JOB TITLE:
 Russell Hotel
 Russell Sq, London

DRAWING TITLE:
 Elevation of Entrance Doors

JOB TITLE:
 Russell Hotel
 Russell Square, London

Door & Frames
GD11.01 & DG23.02

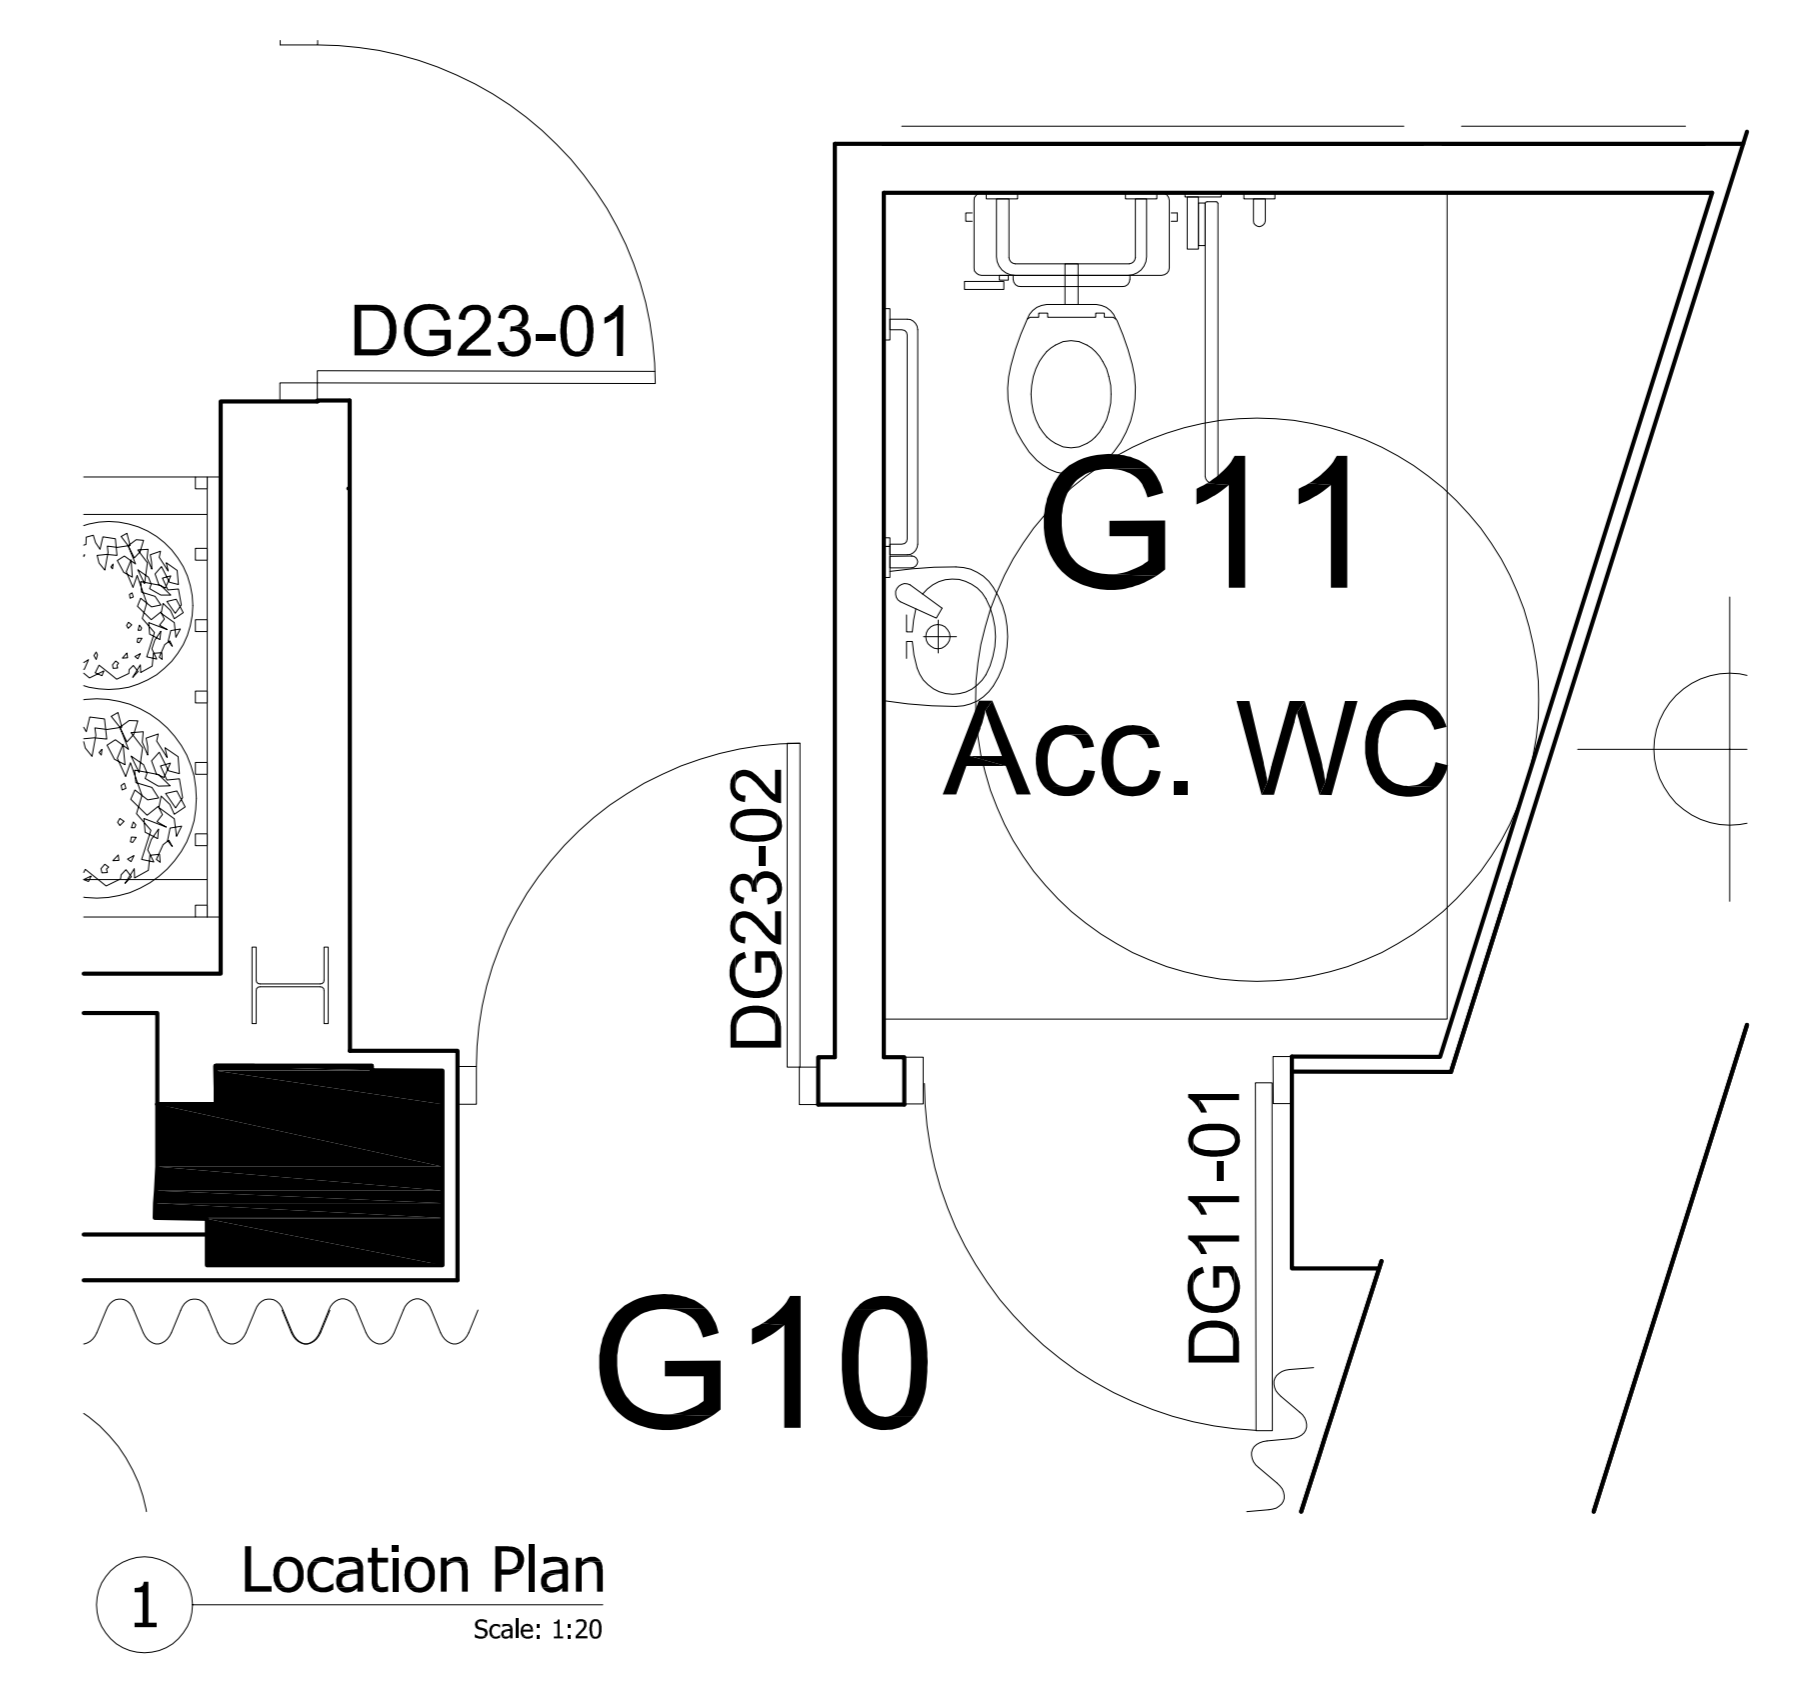
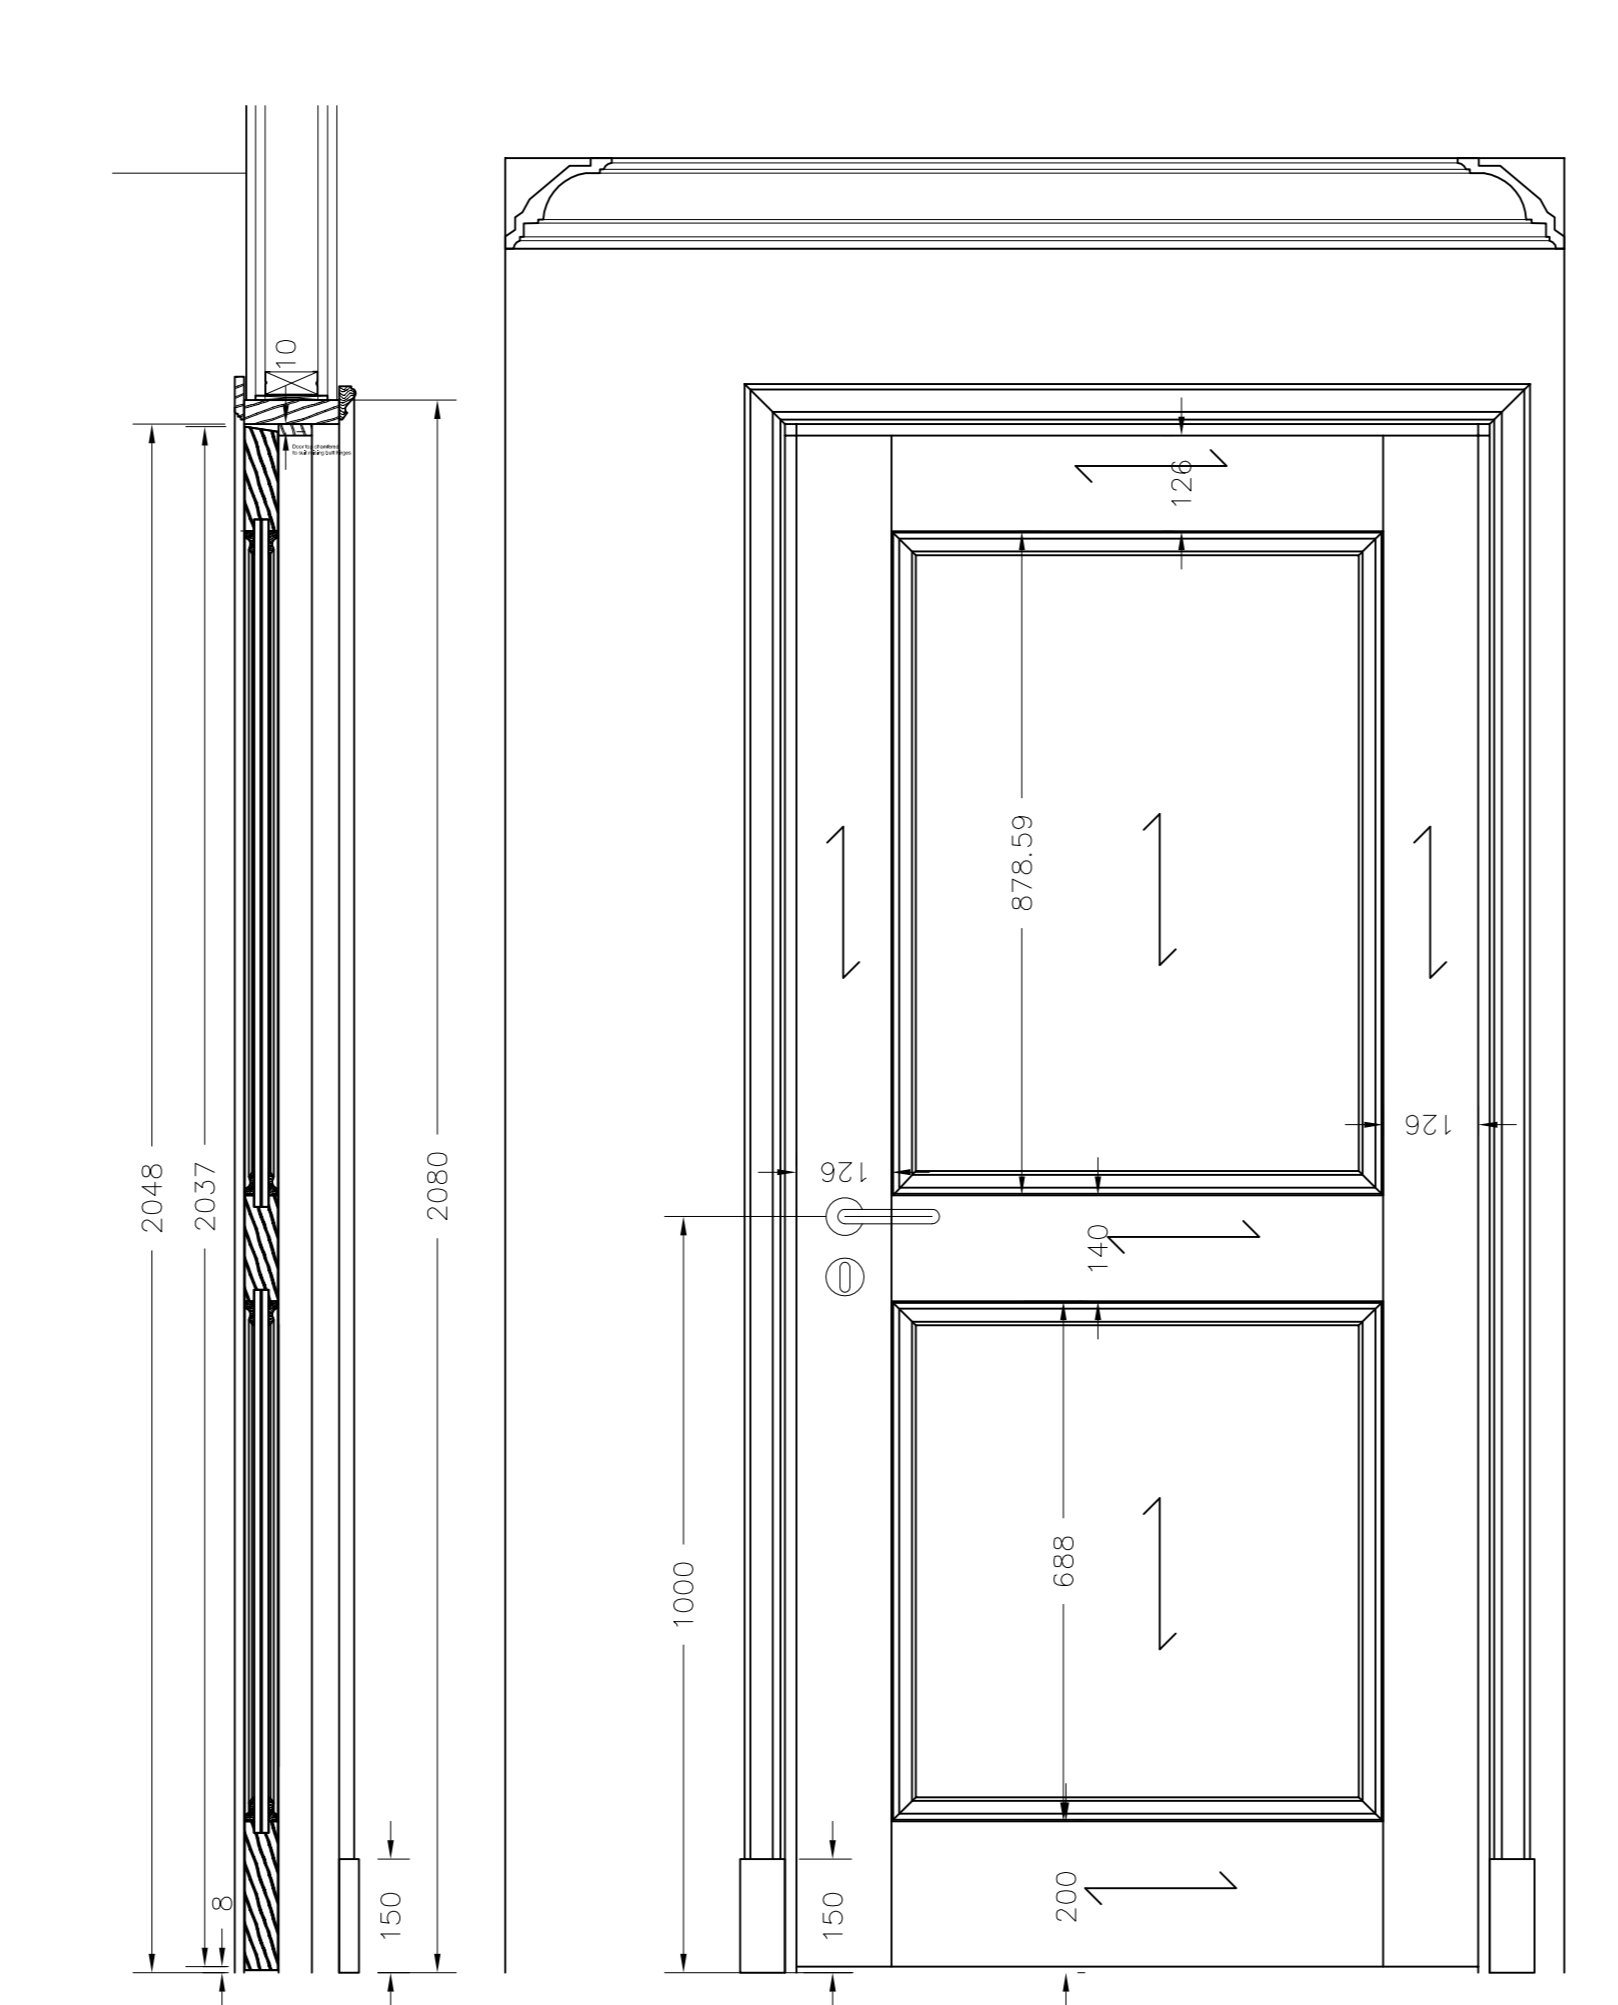
Epr Comments:
Fire spread rating all wall & ceiling surfaces to meeting Ad'B and Fusion Fire Strategy.
